EAGLE LAKE PLANNING COMMISSION  
REGULAR MEETING  
MONDAY DECEMBER 7, 2020 at 6:30 P.M.  
TO BE HELD IN THE COMMISSION CHAMBERS,  
LOCATED AT 675 E EAGLE AVE  
EAGLE LAKE, FLORIDA 33839

**RE: ELAKX20005 – RANCHES AT LAKE MCLEOD NORTH RANCH ENGINEERING PLAN REVIEW**

**RE: ELAKX20005 – RANCHES AT LAKE MCLEOD NORTH RANCH ENGINEERING PLAN REVIEW**

**RE: ELAKX20004 – SUTTON PRESERVE ENGINEERING PLAN REVIEW**

DATE  
08/03/2020  
PROJECT NO.  
1401014  
SHEET NUMBER  
C04

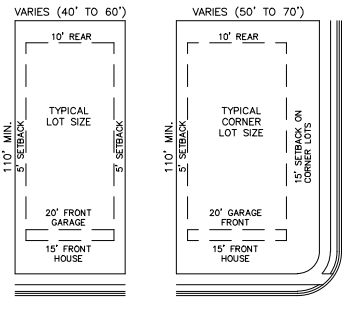
3. Sheet No. CO4, Master Site/Phasing Plan indicates five phases for the overall project. However, there are no demarcation lines to clearly identify these phases. An accurate phasing plan cannot be completed without the required traffic study. However, the applicant should provide an explanation of plans and timing to perform the required traffic study.

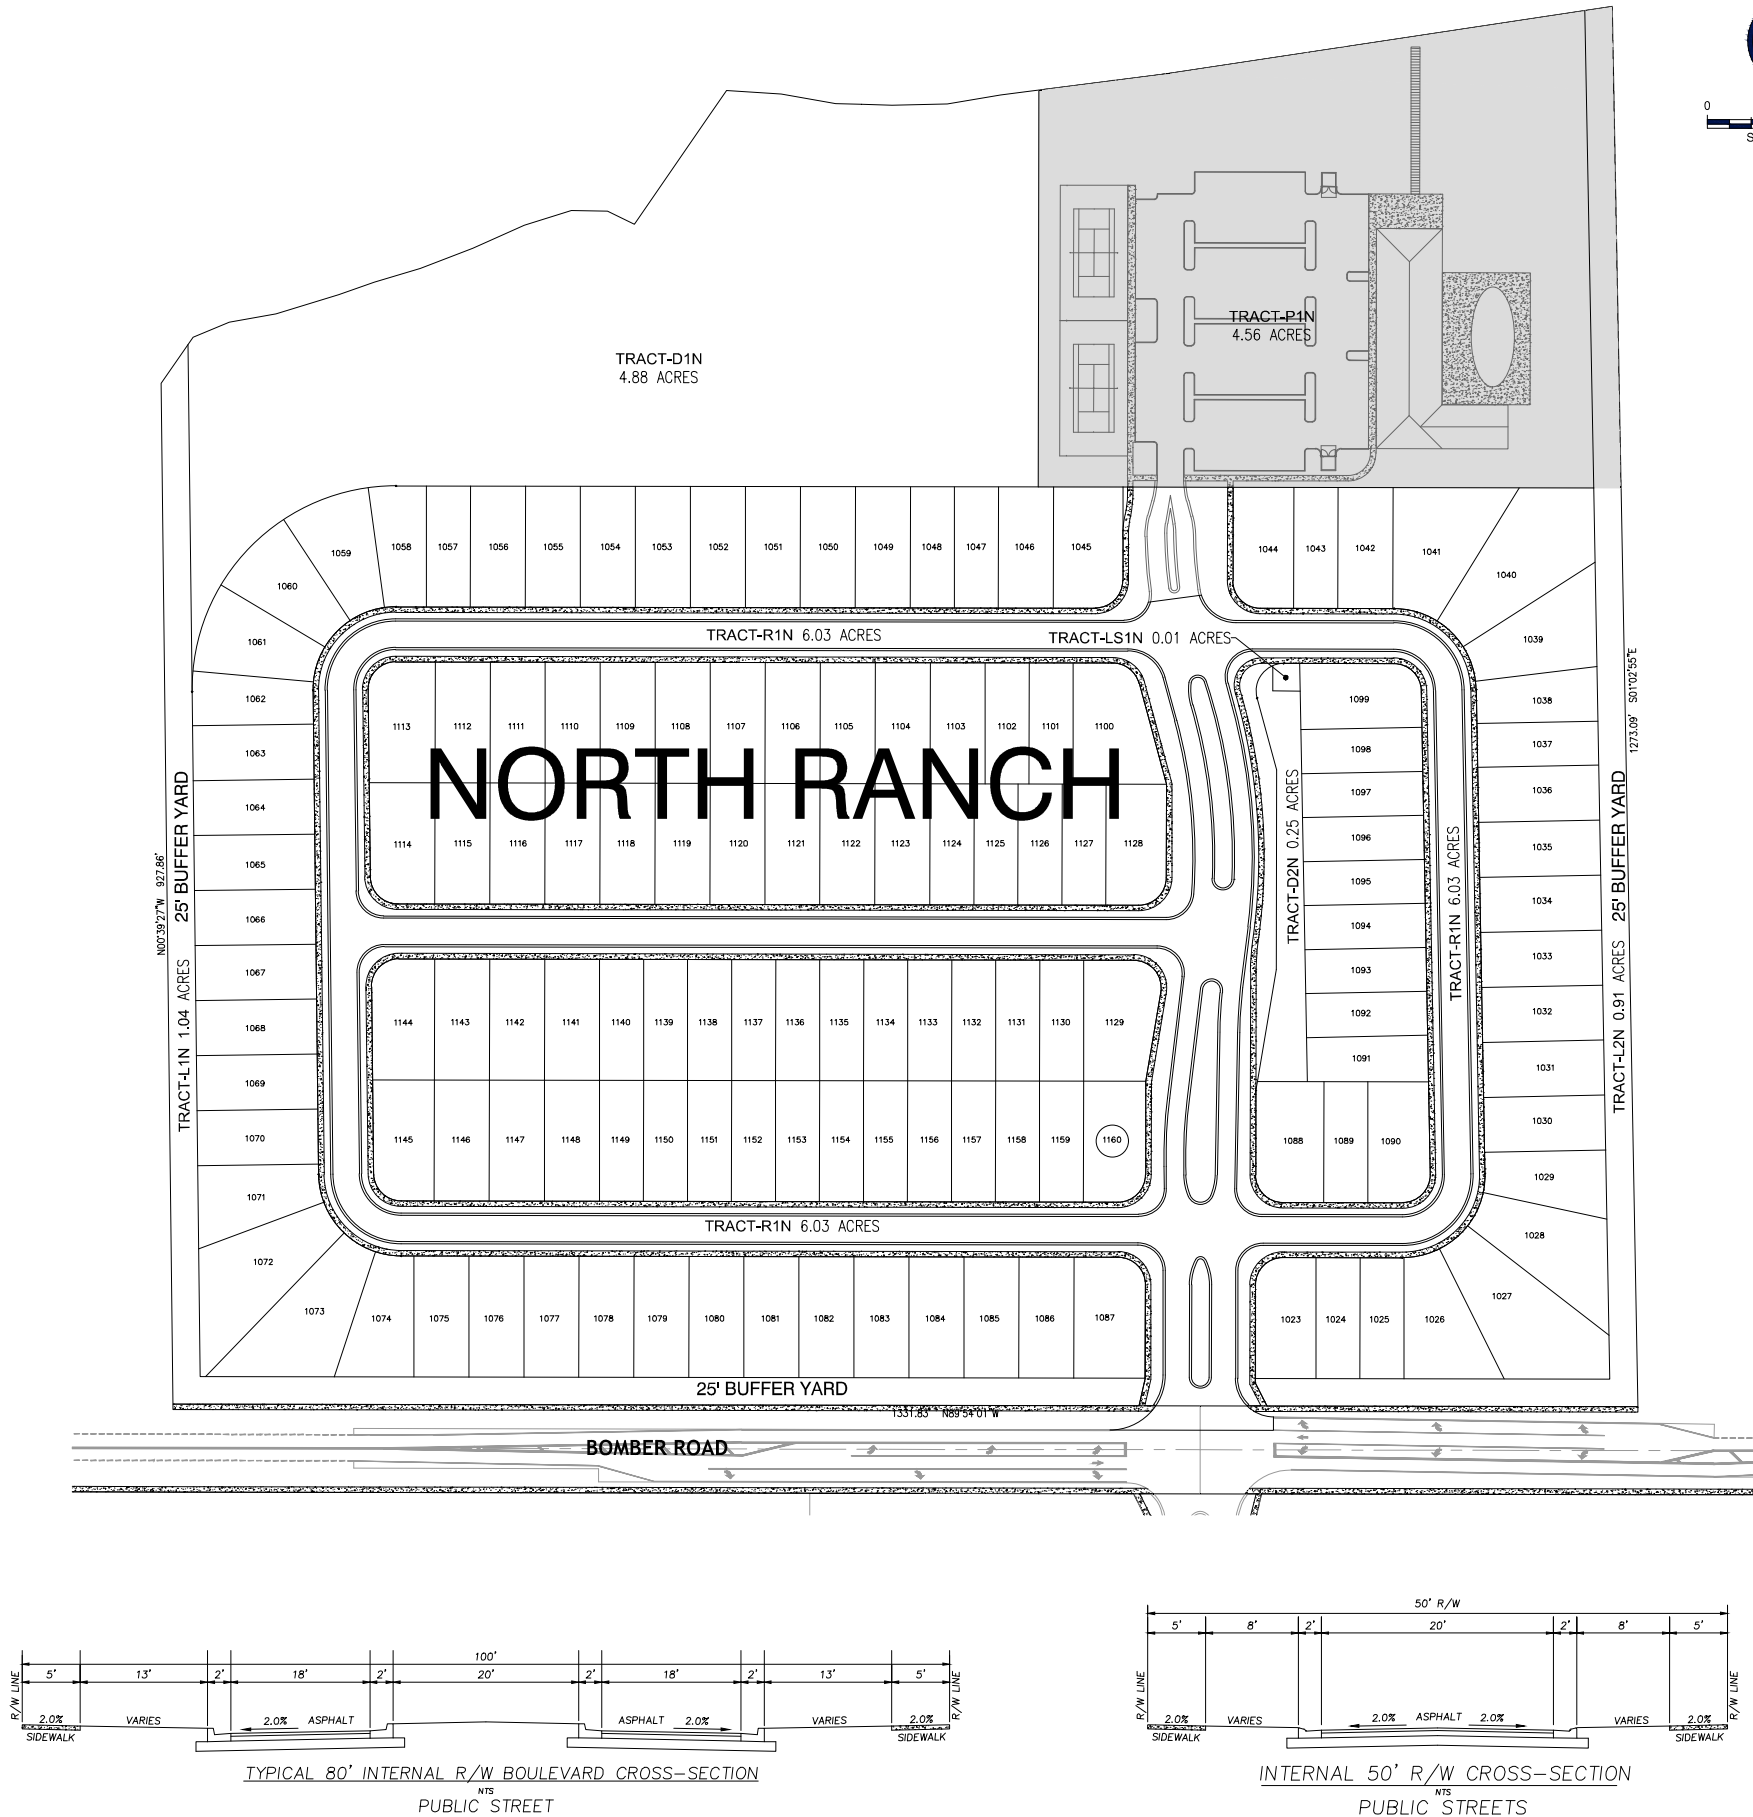
1. The plans reflect 138 lots, which do comply with the approved conceptual master plan and minimum lot size for the PH-H zoning as reflected in Ordinance O-20-19.
2. The lot dimensions, including setbacks and lot coverage, as noted on Sheet C05, Master Plan comply with the approved Ordinance for the project.

SHEET NUMBER  
C500

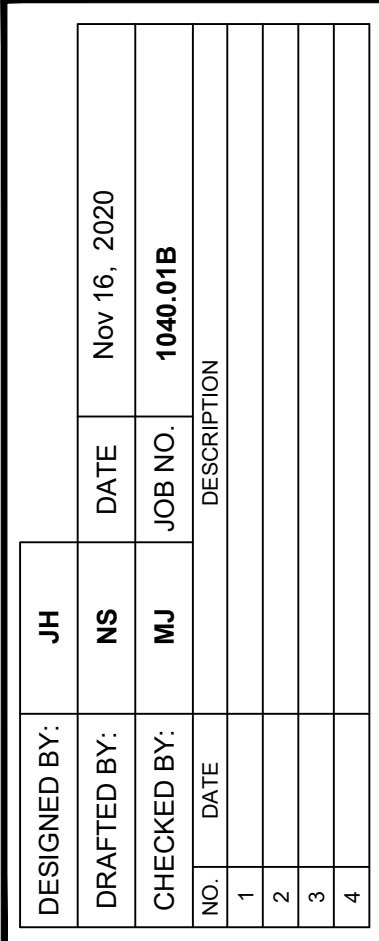
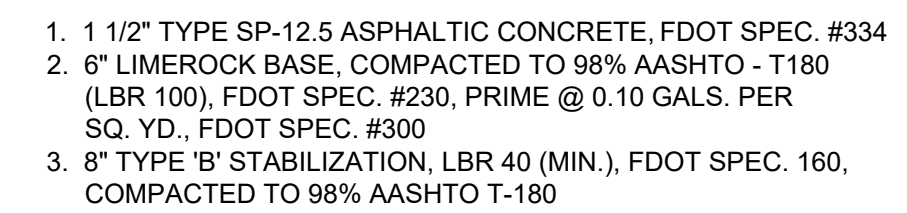
1. The plans reflect 112 lots, which complies with the approved conceptual master plan and minimum lot size for the PD-H zoning as reflected in Ordinance O-20-26.
2. The lot dimensions, including setbacks and lot coverage, as noted on Sheets C500 through C602 complies with the approved PD-H for the project.
